From:Robert BartlettSent:Tuesday, March 23, 2021 9:01 AMTo:Public Hearings Shared; Michelle Mitton; Oksana Newmen; Legislative Services SharedSubject:[EXTERNAL] - Proposed Redesignation and Development of Fawn Hills Bragg Creek

Proposed Redesignation and Development of Fawn Hills Drive, Bragg Creek

PL201901 and PL20190103

Re; Land use re-designation C-7955-2019 (Project PL20190102) and conceptual scheme C-7956-2019 (Project PL20190103)

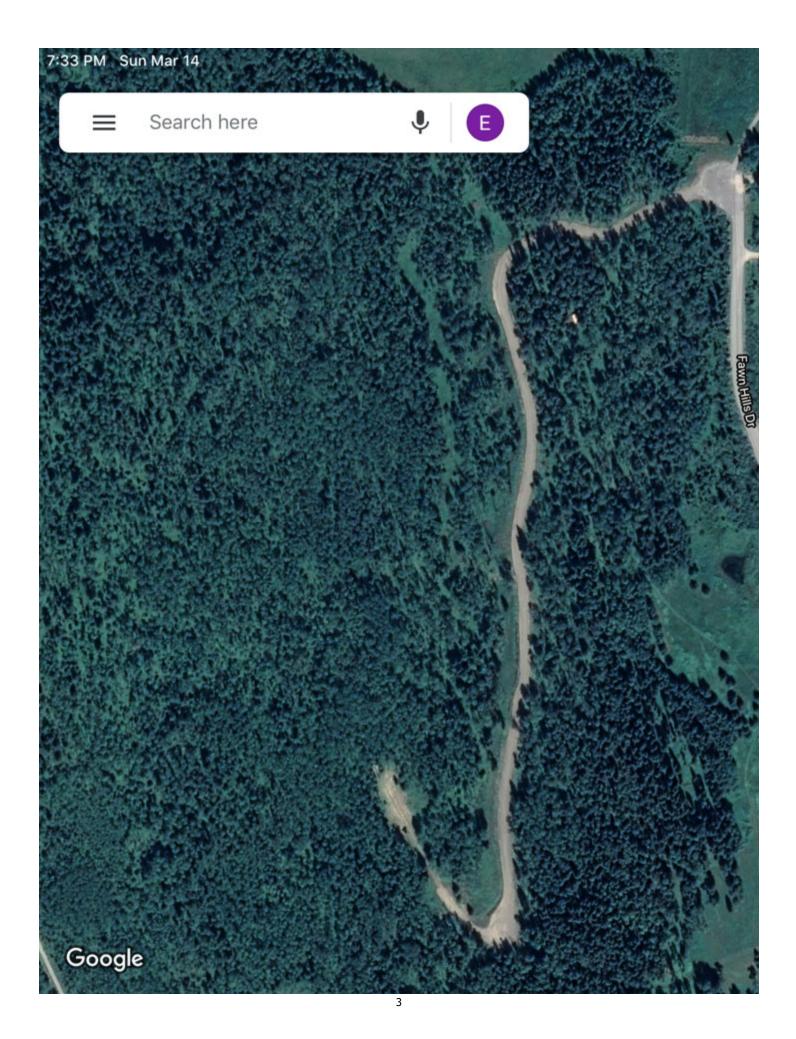
You should be aware that the applicant has already completed construction of most of the proposed subdivision road as per the attached Google map. This would appear to be putting the cart ahead of the horse in terms of proper process for approvals. A RVC Development Permit is required for such road construction under the "stripping, filling, excavation and grading" section of the Land Use Bylaw. The required Development Permit for this road construction doesn't appear to have been issued by RVC.
